RECEIPT DATE: 6-17-24 **ONSITE SEWAGE DISPOSAL SYSTEM** P 586708
 APPROVAL DATE: 2/2/2024 **PERMIT: UPGRADE** A _____
 PROPERTY ADDRESS: 14900 Meriwether Drive
 SUBDIVISION: Meriwether Farm LOT: 30 TAX ID: _____
 CONTRACTOR: Fogles Septic Cleaners EMAIL: Karla.fogles@fogles.com
 CONTRACTOR ADDRESS: 580 Church Hill Sykesville MD 21784 PHONE: 410-455-5670
 PROPERTY OWNER: Todd Travis EMAIL: _____
 OWNER ADDRESS: 14900 Meriwether Drive PHONE: _____

RE: Meriwether Farm -- Lot 30 -- OSDS review
14900 Meriwether Drive
CLSI Job No.: 2023273

From: Eshenbaugh, Melanie
Sent: Wednesday, March 13, 2024 3:41 PM
To: Matt Shipley
Subject: OSDS comments 14900 Meriwether Road

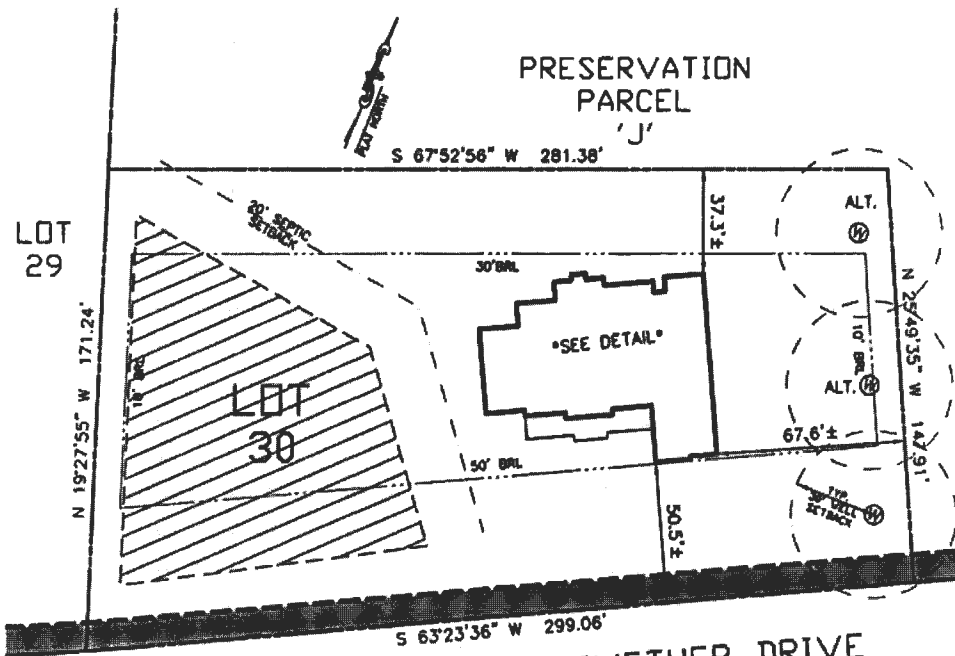
1. The additional trench to the existing system is showing greater than 10' of separation which if shifted some would allow a slight adjustment on the orientation upgradient to better fit the trenches for the 2nd replacement system on contour.

2. Recommend 2-3 long trenches to better align the trenches on contour for the 2nd replacement system (e.g 2@ 94 or 3@ 63')
 - a) If showing any bends in the trench lines those degree fittings would need to be called out

3. The 2nd replacement system indicated 2' of sidewall, but showing 3' on the trench profile & indicated "8' to bottom of trench" under system specs
 - a) Trench #6 indicates a trench bottom of 8' based on system elevations **Still states 8' to bottom*

4. Existing system specs & profile show an invert depth at 4' & the as-built elevation is @ 4.5', will need to confirm *2.5'* elevation/depth
5. Should show length of trenches for the 2 replacement systems

1. The additional trench to the existing system has been moved to exactly 10 feet (sidewall-to-sidewall) at its closest points from the existing Trench #2. All other portions of the trench will follow contour and may be further, but will not be closer than the required 10 feet of separation.

2. With the slight adjustment to Trench #3, I am still unable to fit (3) 63 foot trenches within the SDA and maintain installation on-contour while maintaining the correct trench separation sidewall-to-sidewall. Fittings are now shown and called out where necessary in trenches that cannot be constructed without bending to contour.

3. The trench profile for the second replacement system shows 3 feet of sidewall to prevent the lateral invert from being lower than 4 feet below grade. Effective depth and sizing of the system is still based on 2 feet (from 5-7 feet below grade), however the pipe will sit at 4 feet. The bottom depth of Trench #6 has been revised to be no deeper than the allowable 7 feet.

4. Trench exploration conducted on March 21, 2024 revealed the top of stone at 48" below grade. Lateral invert is at 54". Bottom of trench is 78". The depth of install on the as-built drawing from the original system construction has been confirmed.

5. Lengths of trenches for the two replacement systems are now shown.
